Access Compliance Report

Public Rights-of-Way

(Curb Ramps)

Intersection ID: 5407	Main Street: J_W_CLAY_BV	Cross Street: J_M_KEYNES_DR	Location: E
ADA ID: CABD27242F94	Ramp Type: Perp	Initial Pass/Fail: Fail	Overall Compliance: No
Severity Score: 22.5			
Codes/Mitigation Info/Possible Solution		Field Measurements/Component Compliance

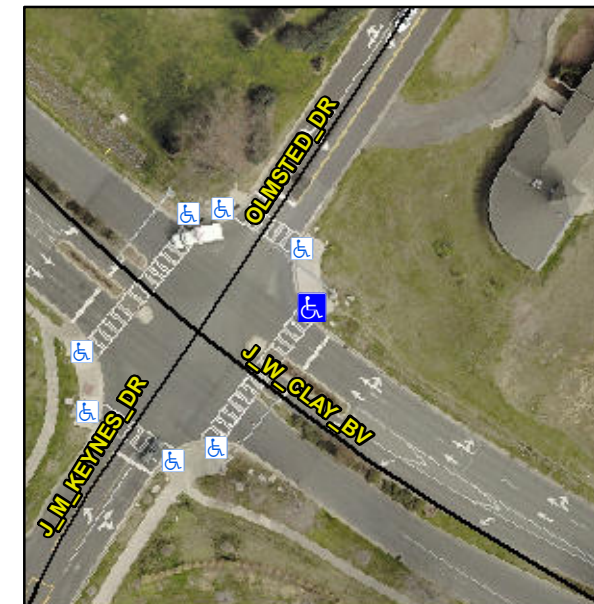
Compliance	Description	Data	Compliance	Description	Data
N/A	Ramp Length (in)	142.0	No	Ramp Slope (%)	8.9
No	Ramp Width (in)	47.5	Yes	Ramp XSlope (%)	2.2
N/A	Flare Type LT	N/A	N/A	Flare Type RT	N/A
N/A	Flare Slope LT (%)	N/A	N/A	Flare Slope RT (%)	N/A
N/A	Flare Traversable LT?	N/A	N/A	Flare Traversable RT?	N/A
N/A	Landing Length (in)	N/A	N/A	DWS Provided?	N/A
N/A	Landing Width (in)	N/A	N/A	DWS Contrast?	N/A
N/A	Landing Slope (%)	N/A	N/A	DWS Length (in)	N/A
N/A	Landing X Slope (%)	N/A	N/A	DWS Full Width?	N/A
N/A	Landing Curb? (Y/N)	N/A	N/A	DWS Offset (in)	N/A
N/A	Shared Landing?	N/A			
N/A	Gutter Ponding?	Yes	N/A	Gutter Slope (%)	N/A
N/A	Gutter Lip Ht (in)	N/A	N/A	Gutter X Slope (%)	N/A
N/A	Painted X Walk1?	No	N/A	Painted X Walk2?	N/A
	X Walk 1 Direction	To SW		X Walk 2 Direction	N/A
N/A	X Walk 1 Width (in)	N/A	N/A	X Walk 2 Width (in)	N/A
	X Walk 1 Slope (%)	0.6		X Walk 2 Slope (%)	N/A
	X Walk 1 X Slope (%)	2.3		X Walk 2 X Slope (%)	N/A

N/A	Ramp inside XWalk1?	N/A	N/A	Ramp inside XWalk2?	N/A
	Road Slope (%)	N/A	N/A	Clear Space?	N/A
	Road X Slope (%)	N/A	N/A	Clear Space to XWalk (in)	N/A
N/A	Any Obstructions?	N/A	N/A	Storm Grate/Utility Hazard?	N/A
	Obstruction Type			Storm Grate/Utility Type	
		N/A			N/A
		Yes		Surface Condition? (G/P)	Good

Possible Solutions:

Remove & Replace Entire Ramp.

PROW/ADA:

R304.5.1, R304.2.2
